ADDENDUM NO. 2

DATE: May 20, 2021
FROM: City of Grand Junction Purchasing Division
TO: All Offerors
RE: G Road Bridge Replacement Project IFB-4914-21-DH

G ROAD BRIDGE REPLACEMENT TRAIL DRAIN PLAN & PROFILE

C08
61

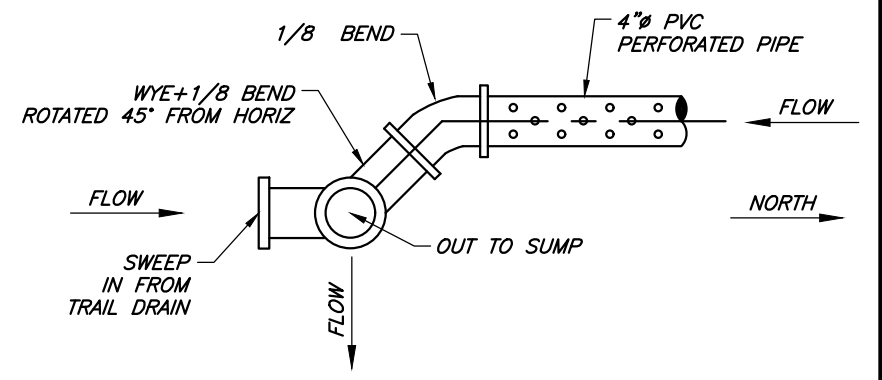
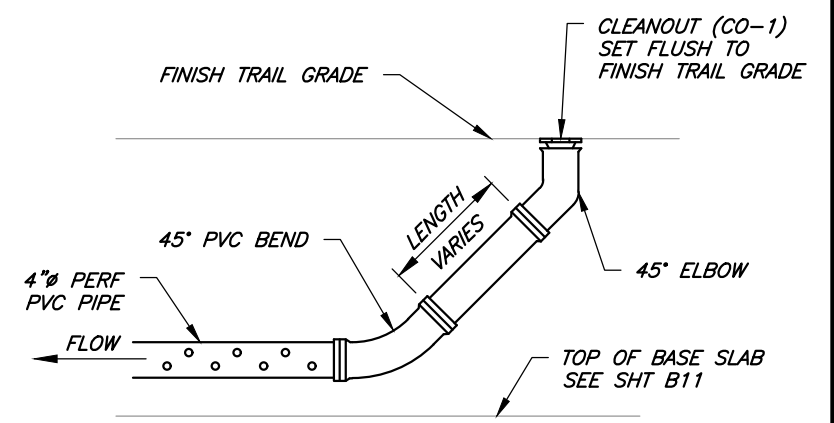
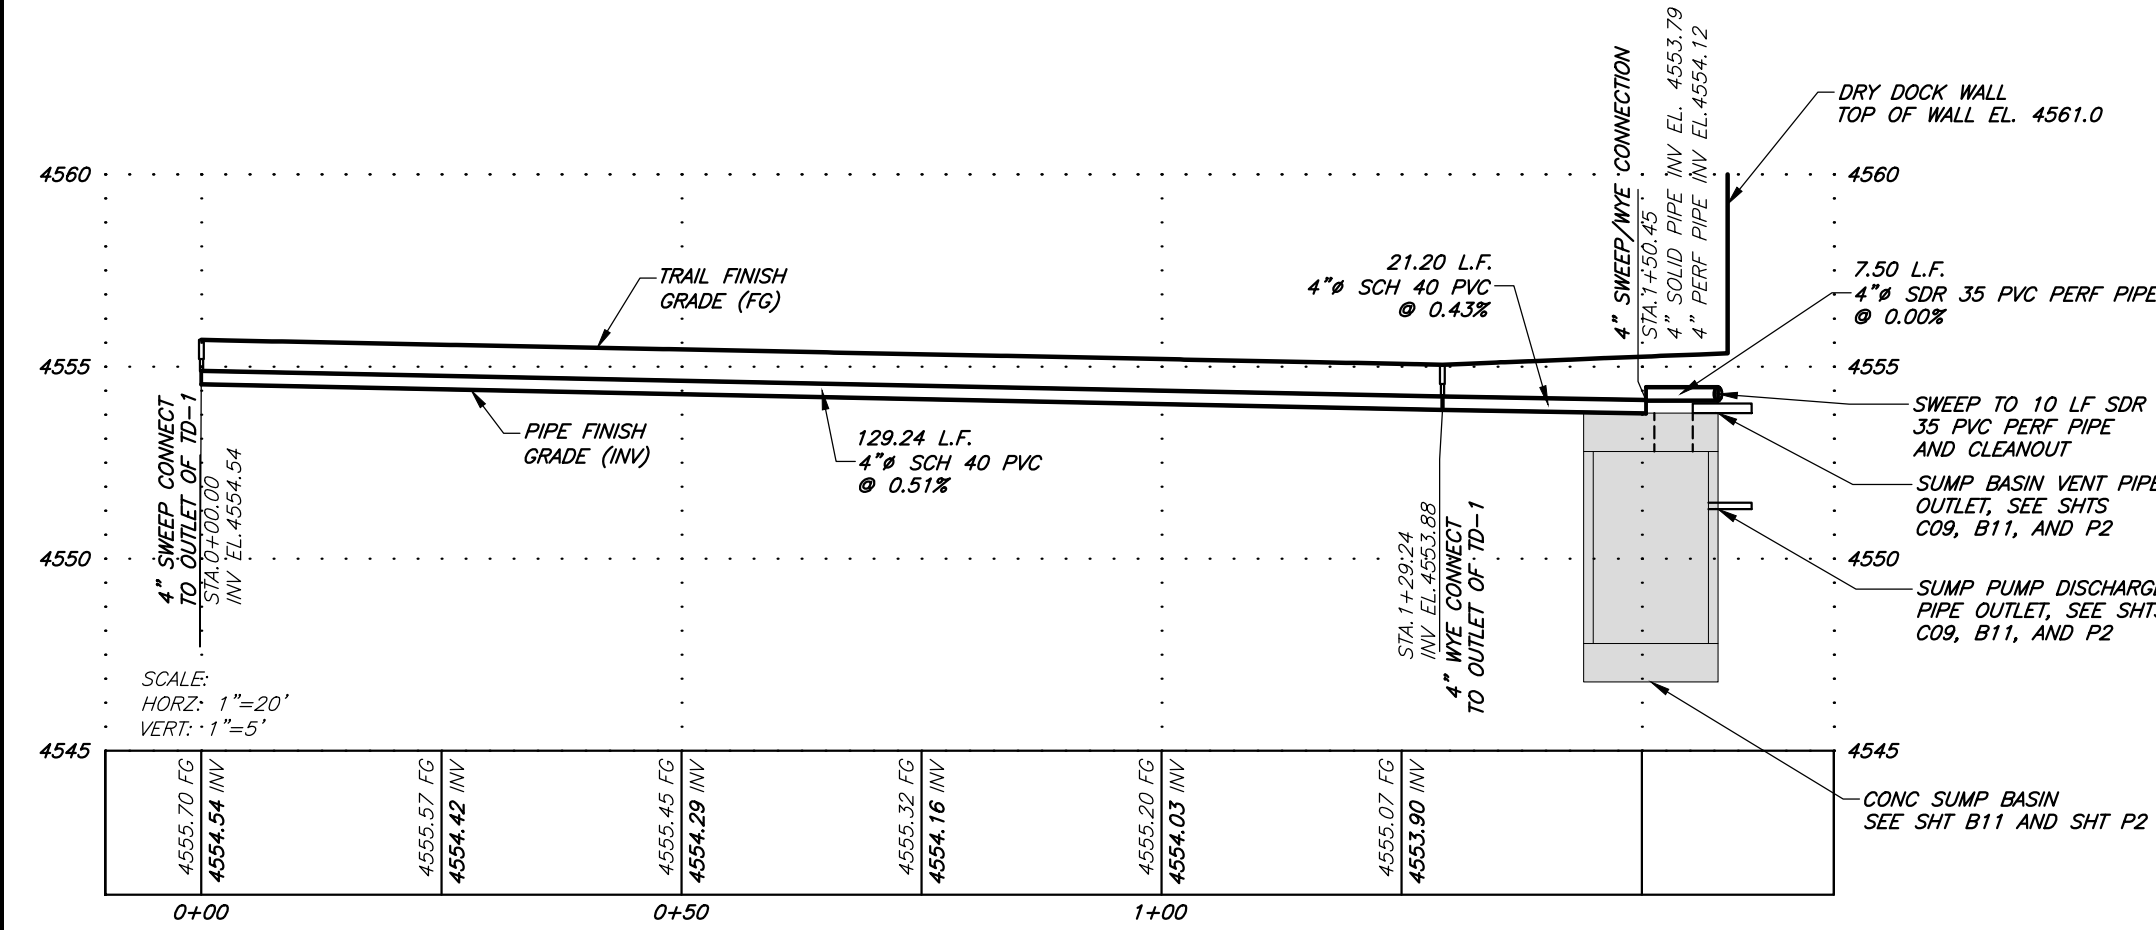
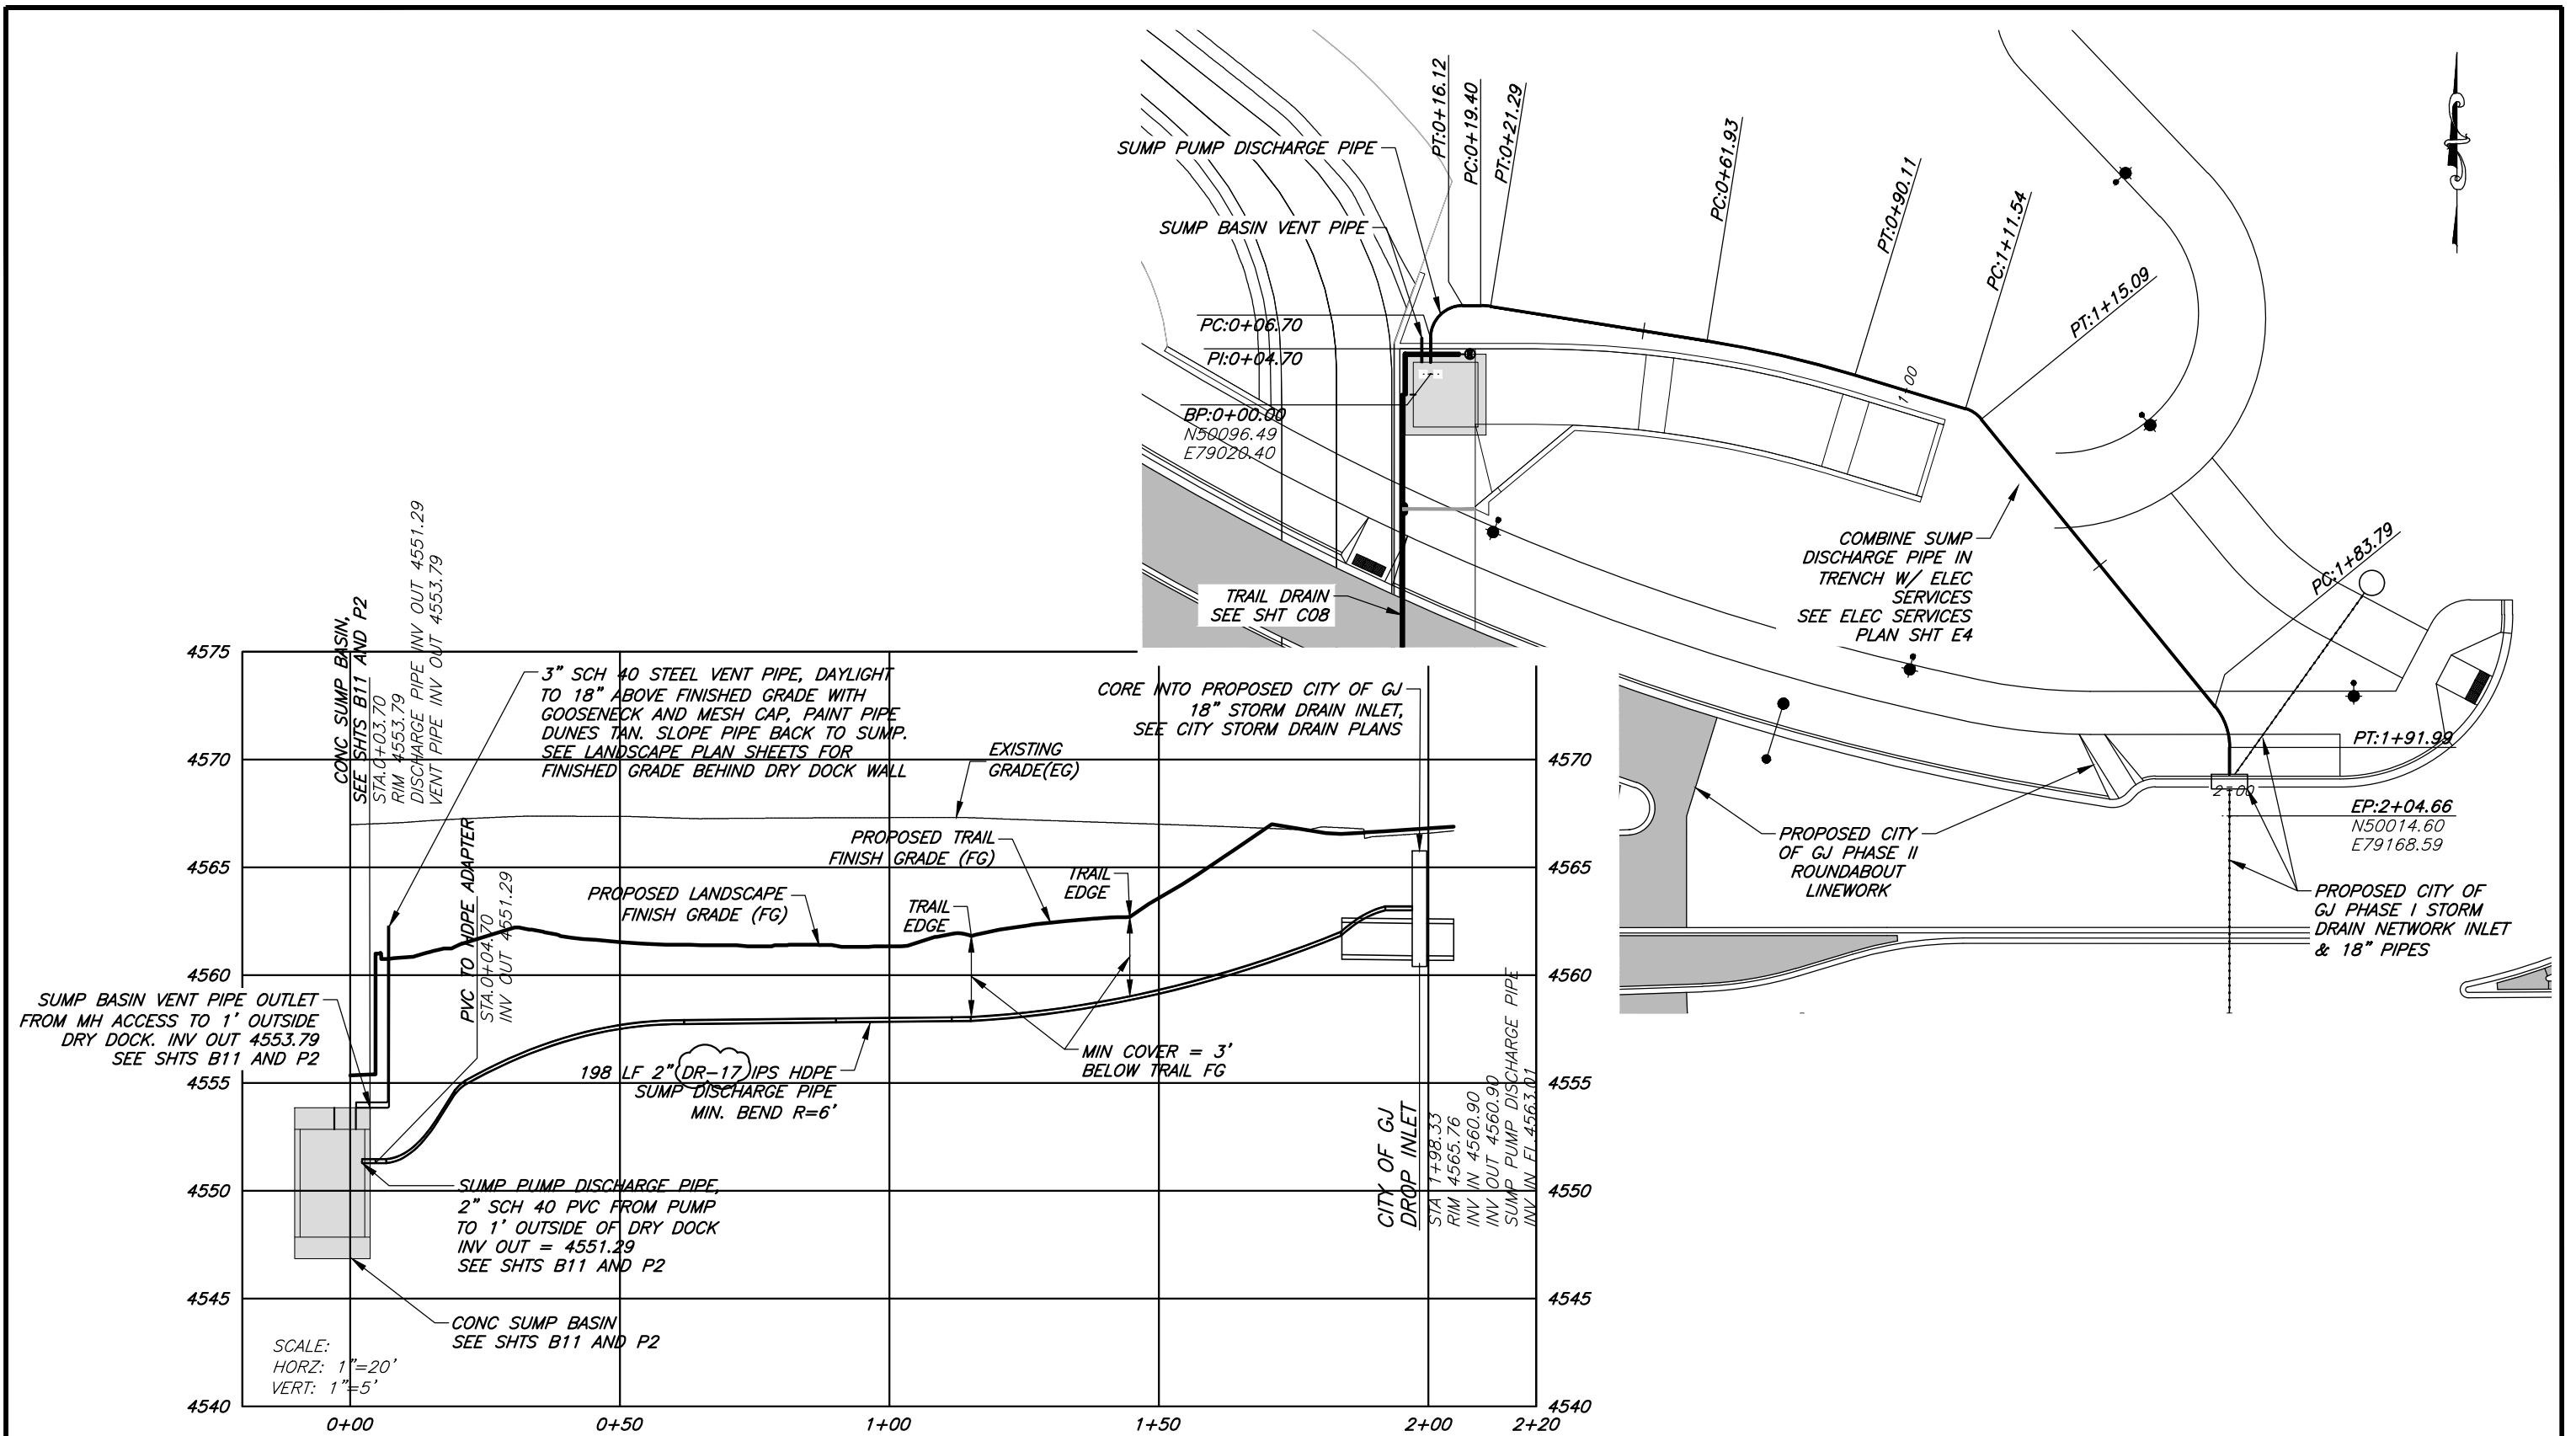
9. Q. Item #130 trench drain. Bid schedule has 29 ft but detail page #61 says 14ft, meaning 2 runs of 14ft?? Making it 28ft? Also on page #61 trench drain outlet says 6" but all piping is 4"? And c/o is 4" but says 6" brass cover?

A. The bid quantity has been changed to 28 ft. Sheet C08 has been updated with the corrections and is included with Addendum #2.

REVISION	DESCRIPTION	DATE
1	Update trench drain model f. KAR	05/18/21
2		
3		
4
